Octant 4 Integration Study

Ovoid Fire Door

D. del Álamo – EN-ACE-INT

08-05-2024

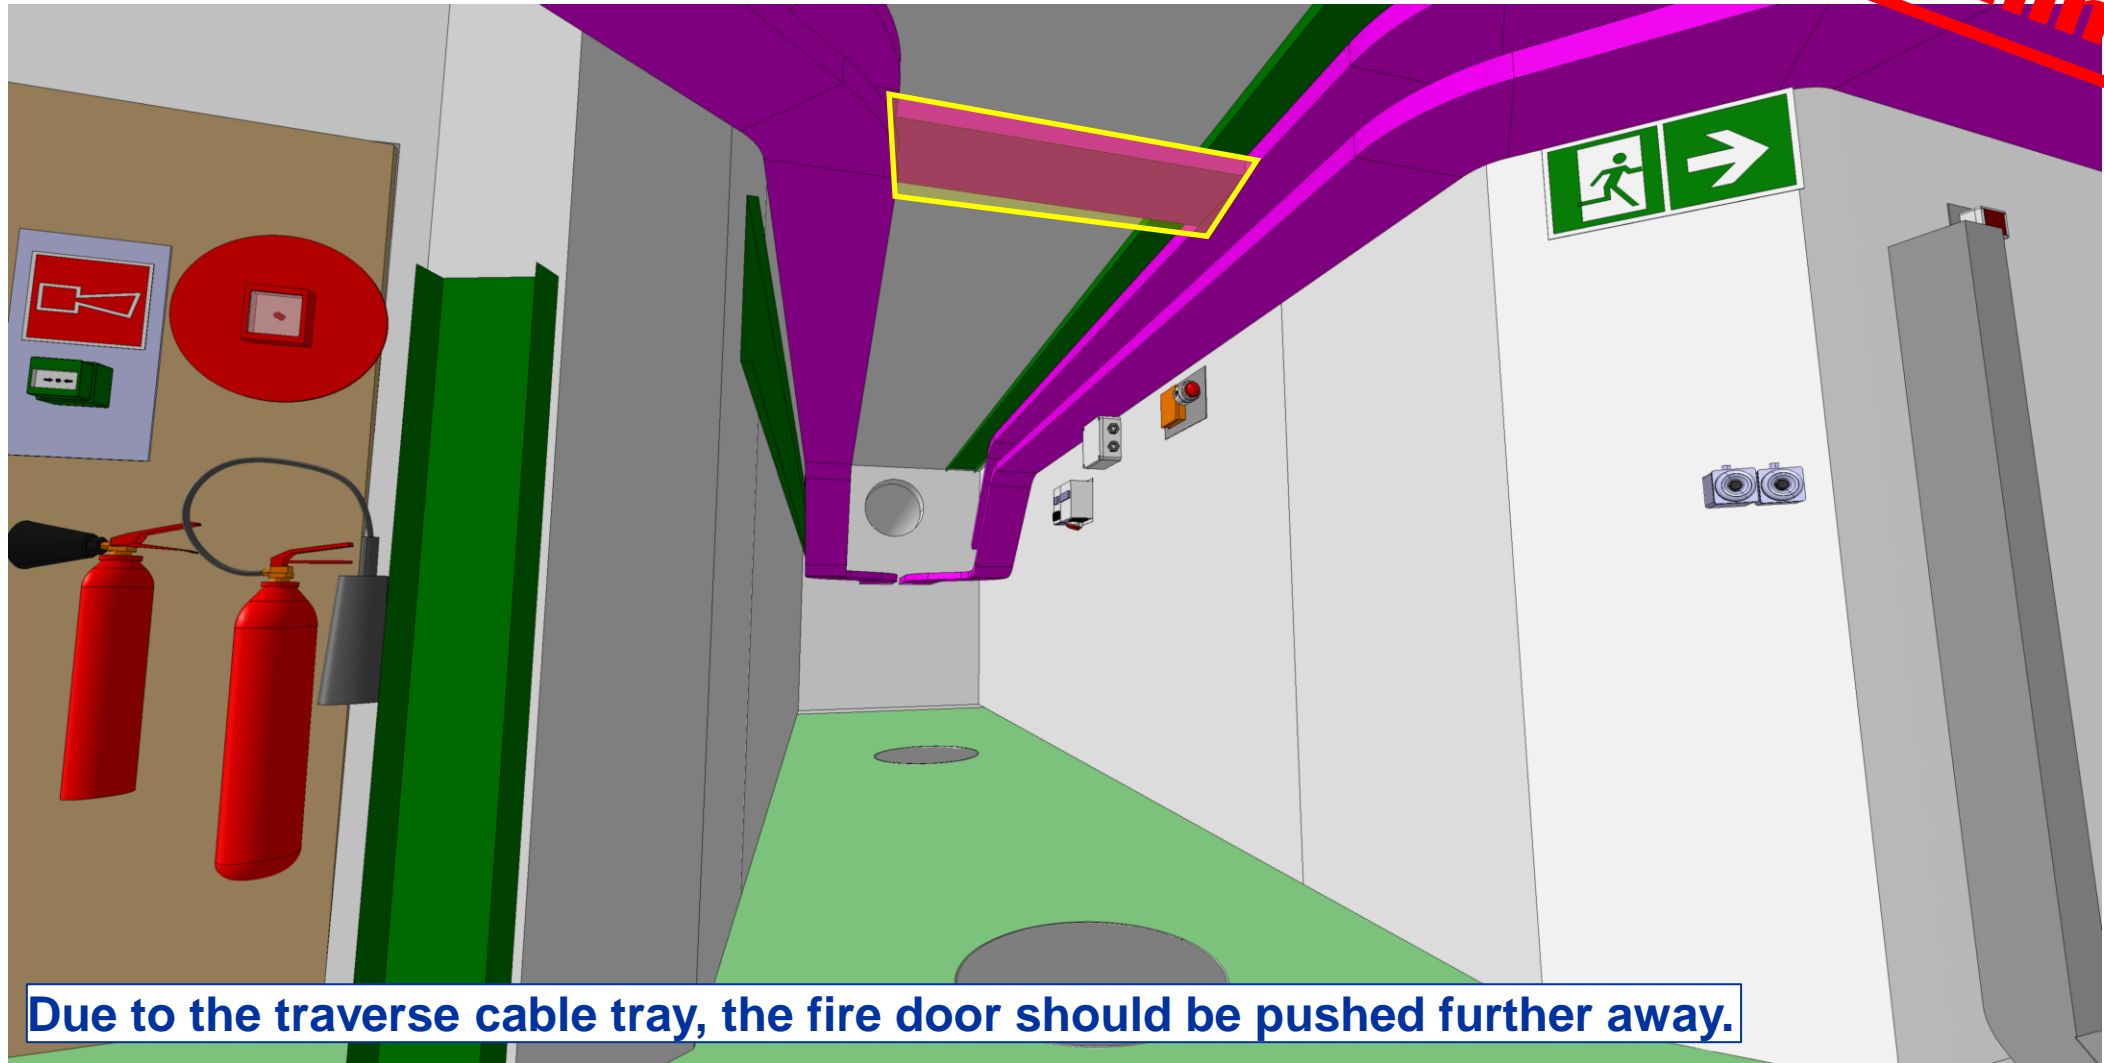
The door should not block the sewer access.

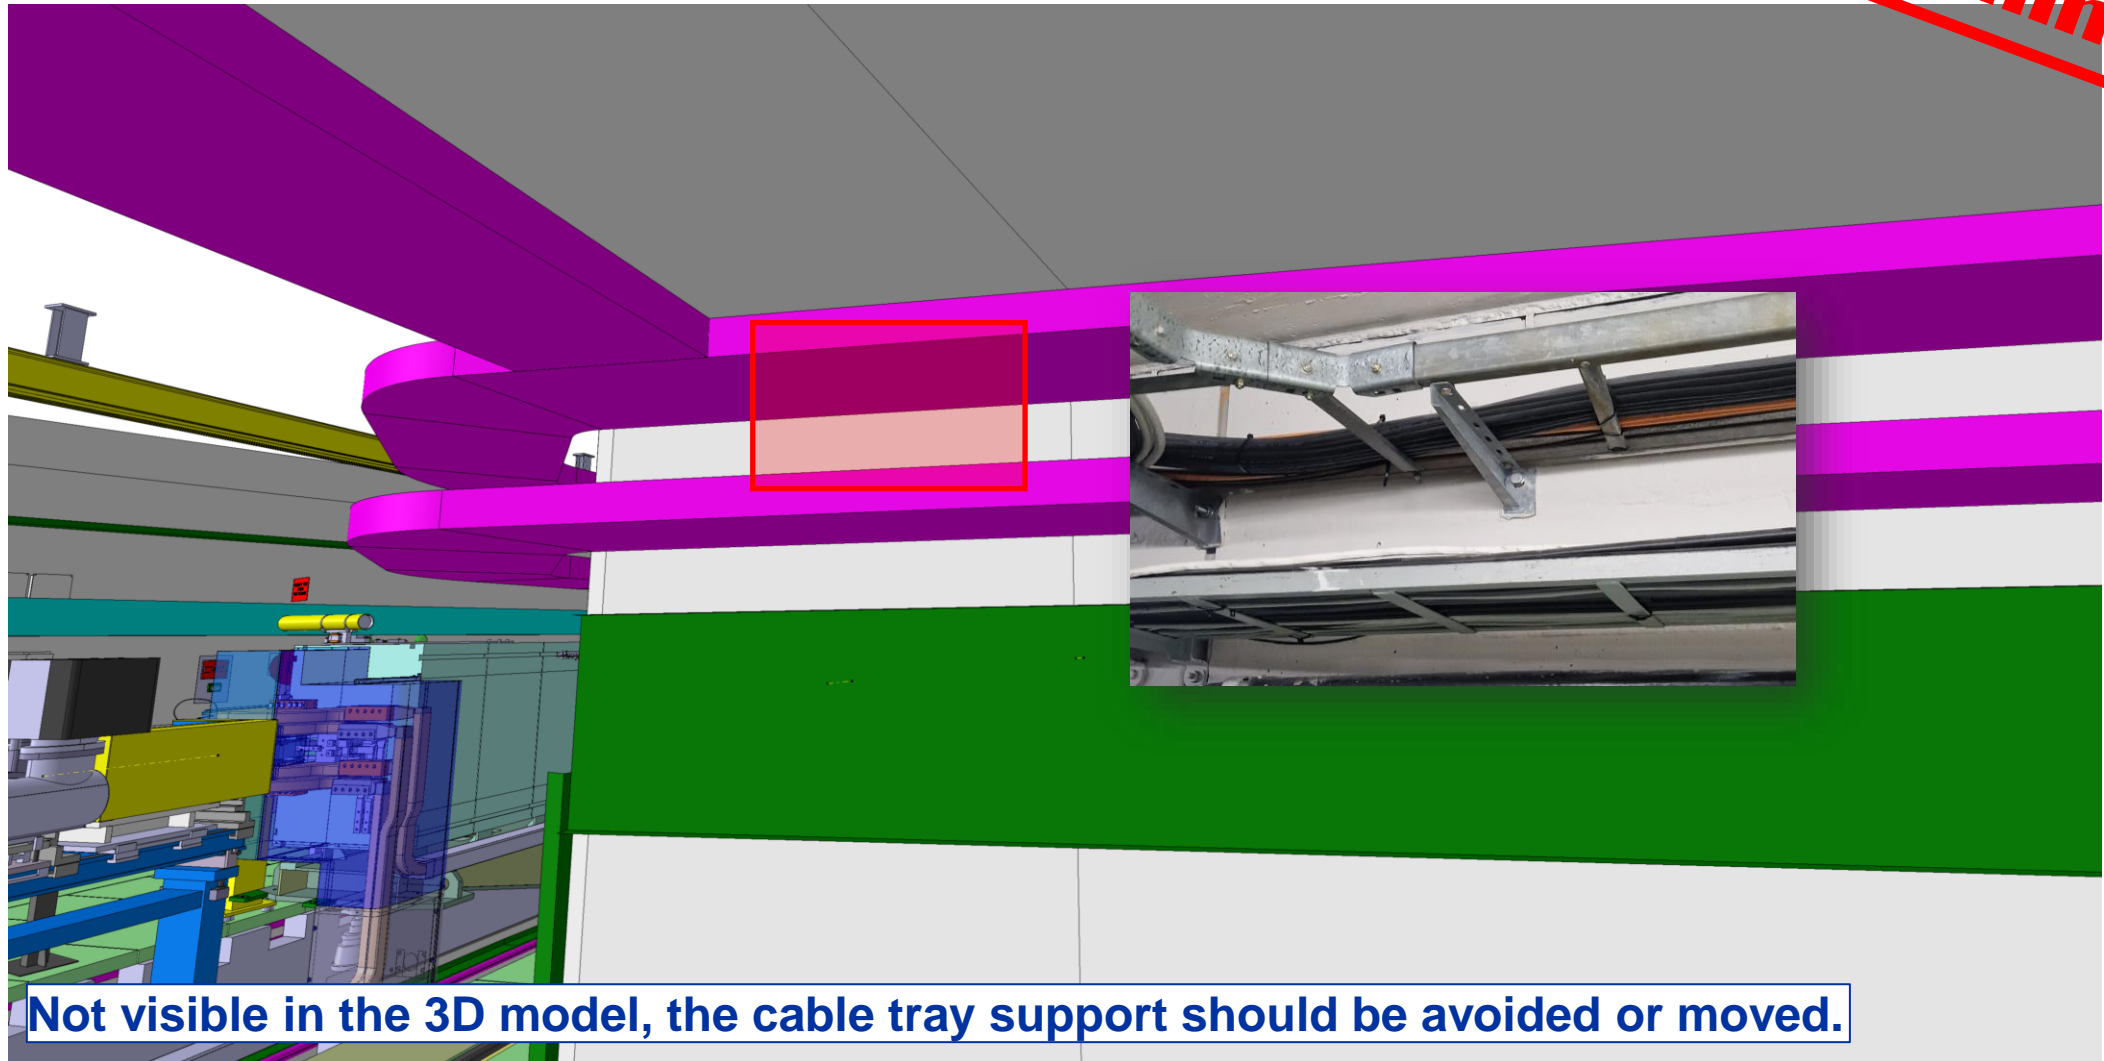
Due to the traverse cable tray, the fire door should be pushed further away.

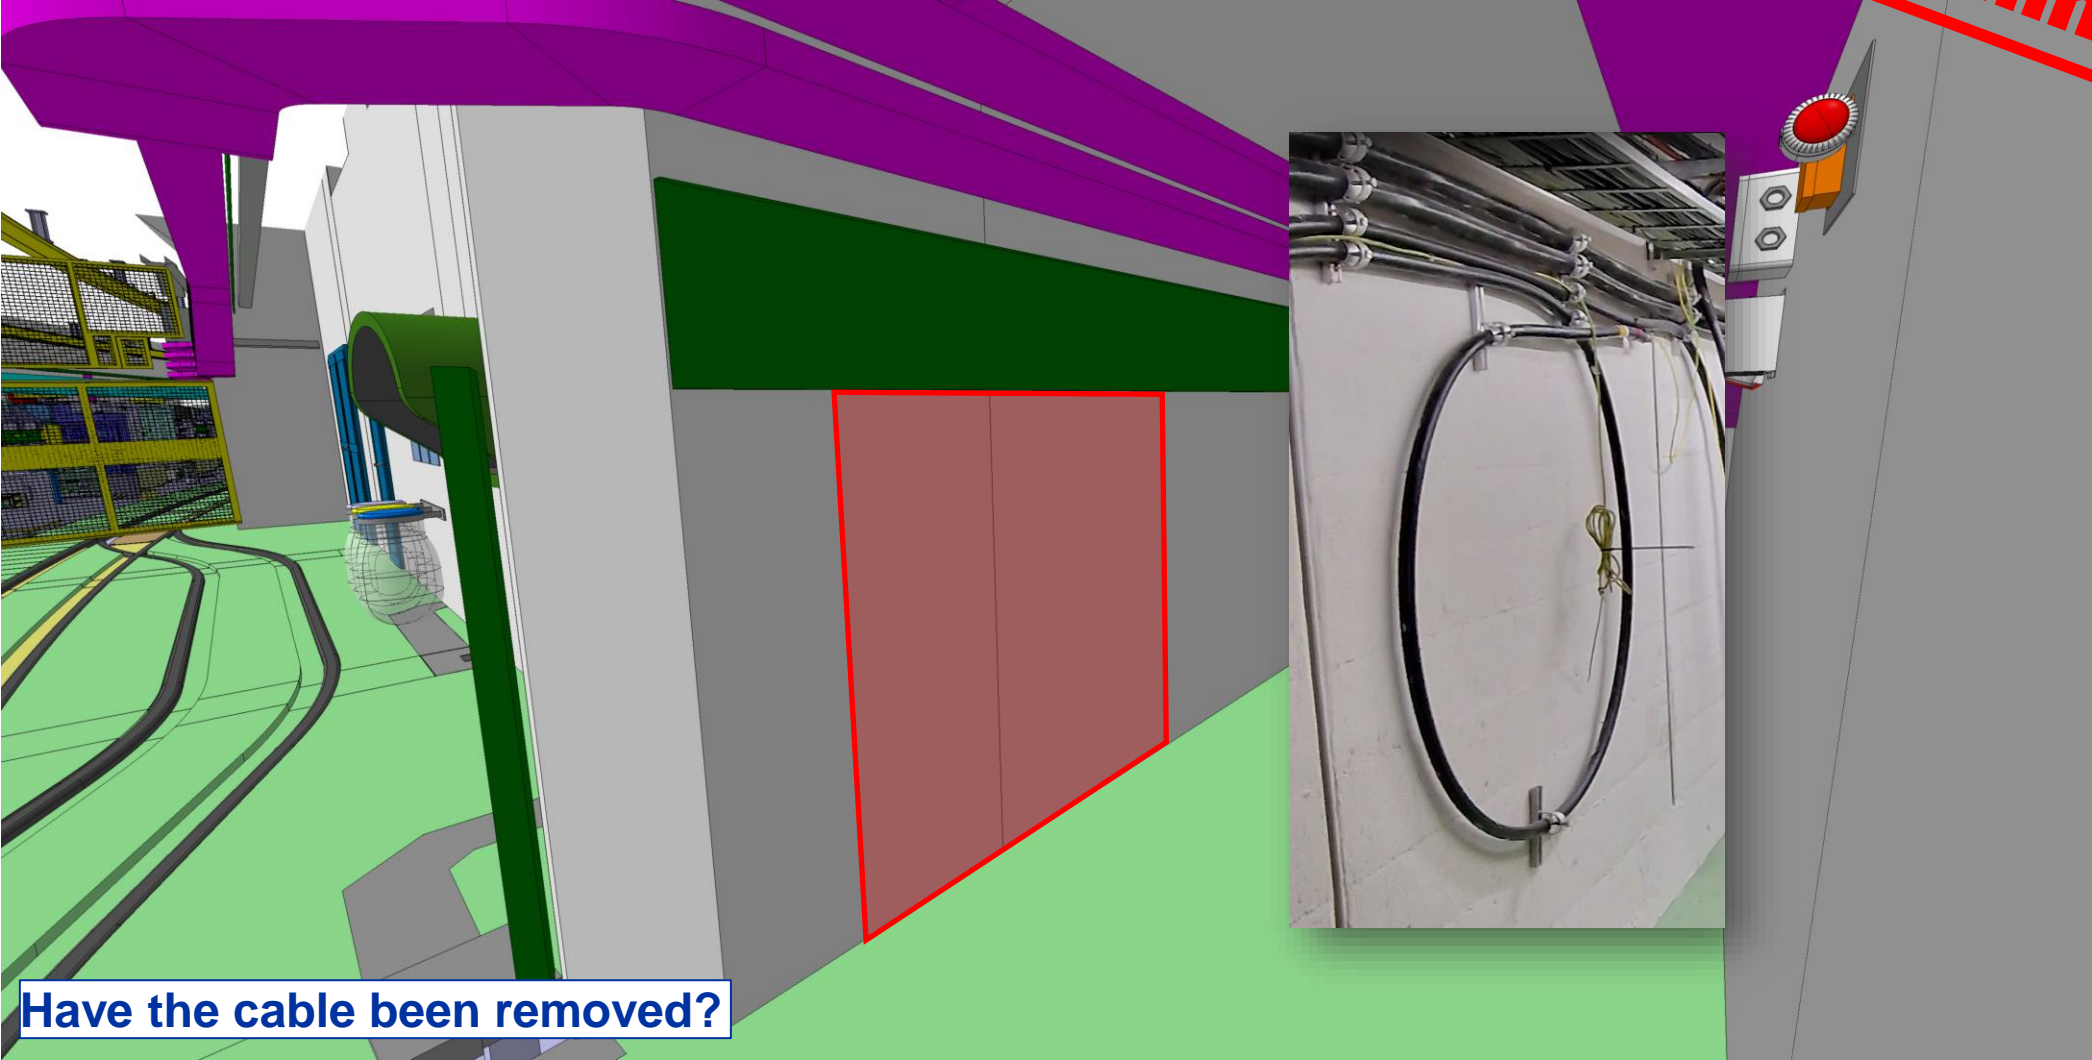
Not visible in the 3D model, the cable tray support should be avoided or moved.
